## **LUMPKIN SUBDIVISION**

APPLICATION NUMBER 6 DATE October 20, 2016

APPLICANT Lumpkin Subdivision

REQUEST Subdivision

# DETAIL SITE PLAN

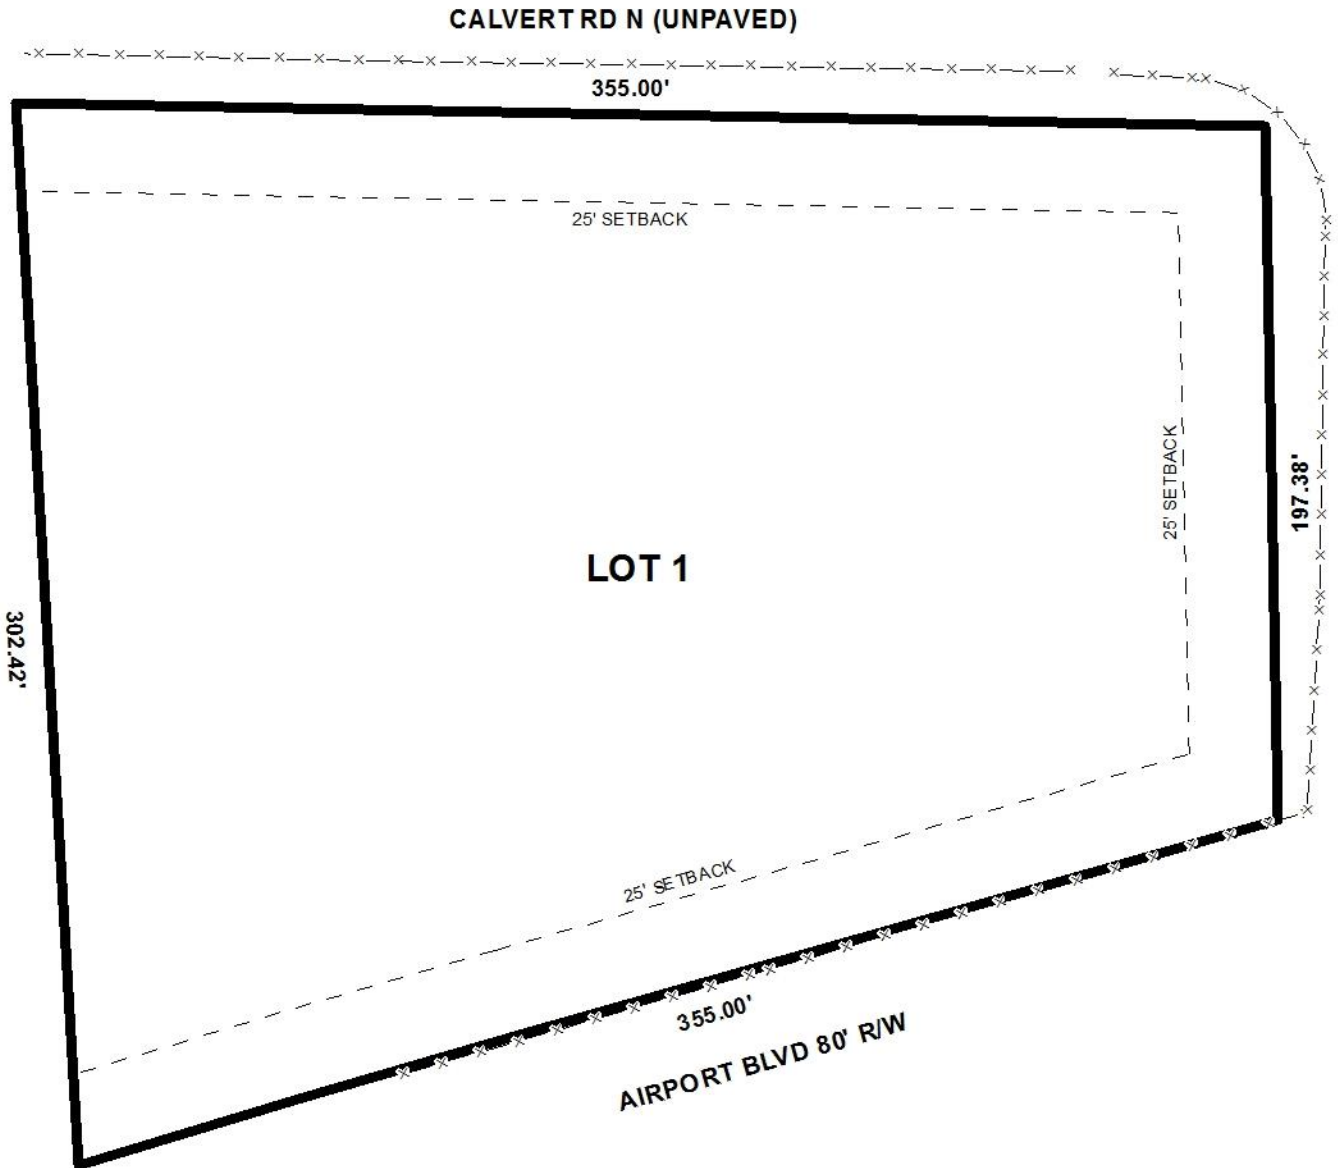
The site has frontage along Airport Boulevard and Calvert Road North. Airport Boulevard is a component of the Major Street Plan with a planned 100' right-of-way. As the plat indicates a current right-of-way width of 80', dedication to provide 50' from the centerline of Airport Boulevard would be required. Calvert Road North is an un-paved road and the plat indicates a current right-of-way width along all portions of the site of at least 30' from the centerline of Calvert Road North; therefore, no dedication would be required. A 25' corner radius dedication would be required at the intersection of Airport Boulevard and Calvert Road North and at the Northeast corner of the site at the turn of Calvert Road North. The 25' minimum building setback line should be revised along Airport Boulevard to be measured from any required right-of-way dedication.

The proposed lots meet the minimum size requirements of the Subdivision Regulations. The plat should be revised to label the lot with its size in both square feet and acres, after required dedications, or a table should be furnished on the Final Plat providing the same information.

As the lot would have slightly more than 200 linear feet of frontage along Airport Boulevard, a note should be placed on the Final Plat stating that Lot 1 is limited to two curb cuts to Airport Boulevard, with the size, location and design to be approved by Mobile County Engineering and conform to AASHTO standards. Access to Calvert Road North should be denied until such time it is paved in asphalt or similar material to Mobile City Engineering standards. Once improved, the lot should be limited to a maximum of three curb cuts to Calvert Road North. If the site is developed commercially, a note should be required on the Final Plat denying access to all portions of Calvert Road North.

The plat does not indicate any easements on the site. If any easements are illustrated on the Final Plat, a note should be required on the Final Plat stating that no structures may be placed or constructed within any easement.

The site is a portion of a much larger tax parcel which is dissected by several roads and is not contiguous. However, the portion containing the site is contiguous and contains a large area to the West indicated as Future Development on the plat. The Final Plat should be revised to also include the entirety of the Future Development area.

- 1) dedication to provide 50' from the centerline of Airport Boulevard;
- 2) dedication of a 25' corner radius at the intersection of Airport Boulevard and Calvert Road North;

- 3) dedication of a 25' corner radius at the Northeast corner of the site at the turn of Calvert Road North;
- 4) revision of the 25' minimum building setback line along Airport Boulevard to be measured from required dedication;

- 5) revision of the plat to label the lot with its size in both square feet and acres, after required dedications; or the furnishing of a table on the Final Plat providing the same information;

- 6) placement of a note on the Final Plat stating that Lot 1 is limited to two curb cuts to Airport Boulevard, with the size, location and design to be approved by Mobile County Engineering and conform to AASHTO standards;

- 7) placement of a note on the Final Plat stating that if Lot 1 is developed commercially, access is denied to all portions of Calvert Road North;
- 8) placement of a note on the Final Plat stating that Lot 1 is denied access to Calvert Road North until it is improved;

- 9) if any easements are illustrated on the Final Plat, a note is required on the Final Plat stating that no structures may be placed or constructed within any easement;
